UNITED STATES PATENT AND TRADEMARK OFFICE

APPLICATION NO.	FILING DATE	FIRST NAMED INVENTOR	ATTORNEY DOCKET NO.	CONFIRMATION NO.
10/662,579	09/15/2003	Kenneth M. Spink	02-ASD-184 (GT)	9319
200	7590	03/29/2006	EXAMINER	
EATON CORPORATION EATON CENTER 1111 SUPERIOR AVENUE CLEVELAND, OH 44114			OMGBA, ESSAMA	
			ART UNIT	PAPER NUMBER
			3726

Office Action Summary

DETAILED ACTION

Fig. 2

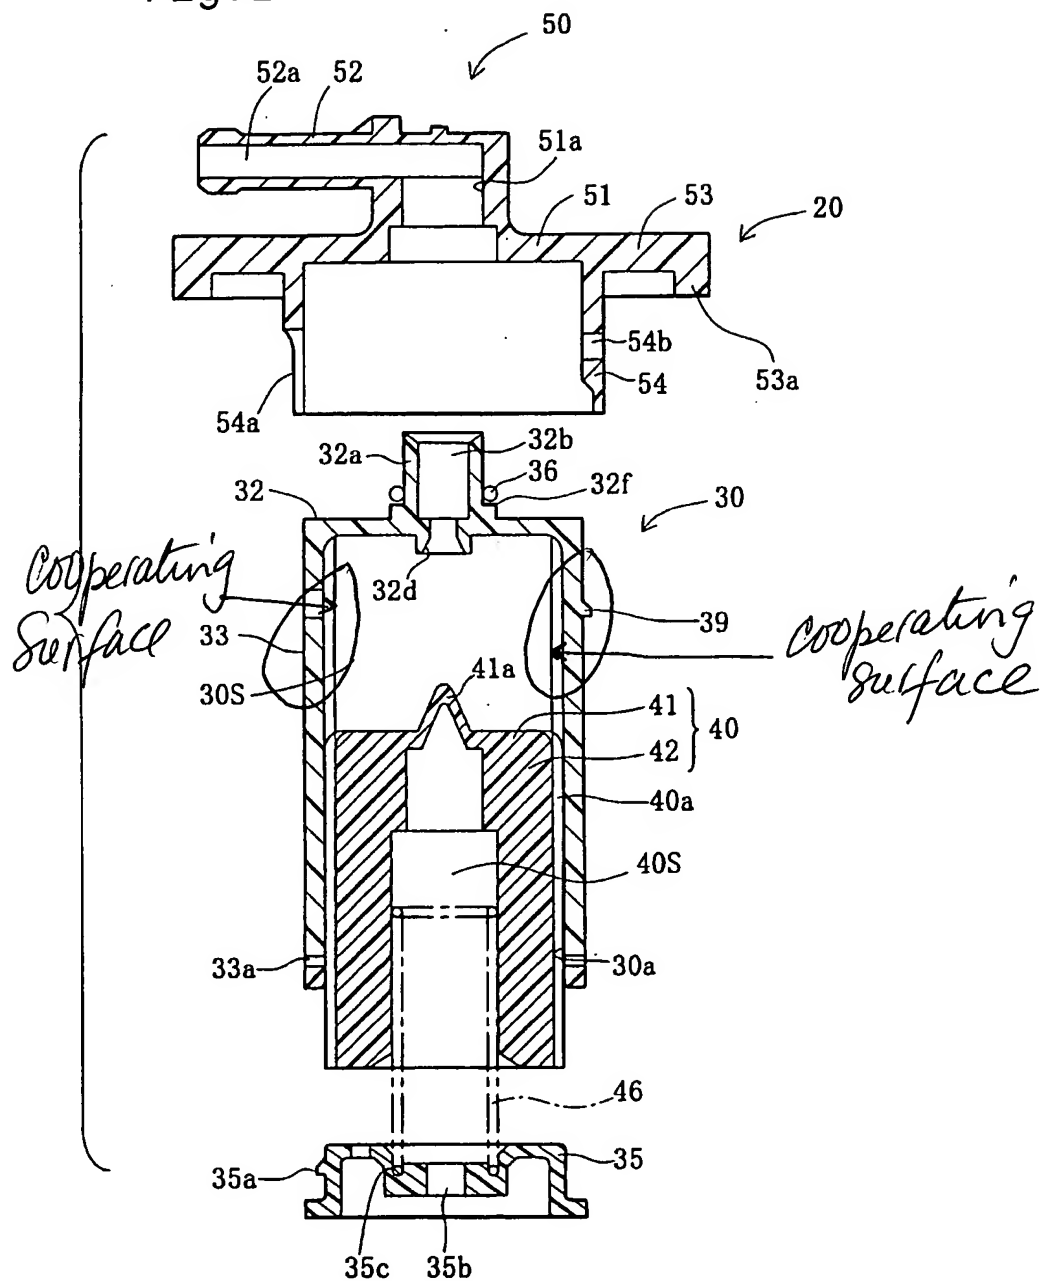
In response to Applicant's argument that "nothing in Aoki suggests engaging cooperating surfaces that prevent relative rotation between the float and the float chamber", the examiner respectfully disagrees. In column 5, lines 18-20, Aoki states that "A guide rib 40a is formed along the outside periphery of the float 40 and is **guided** by an inside wall of the casing", this clearly suggests a "guiding groove" that can clearly be seen in figures 1 and 2: as float 40 is introduced in casing 30, guide ribs 40a are seen engaging cooperating slots or grooves (see the encircled and marked portions of the attached figure), and this engagement will prevent the float from rotating within the float chamber.
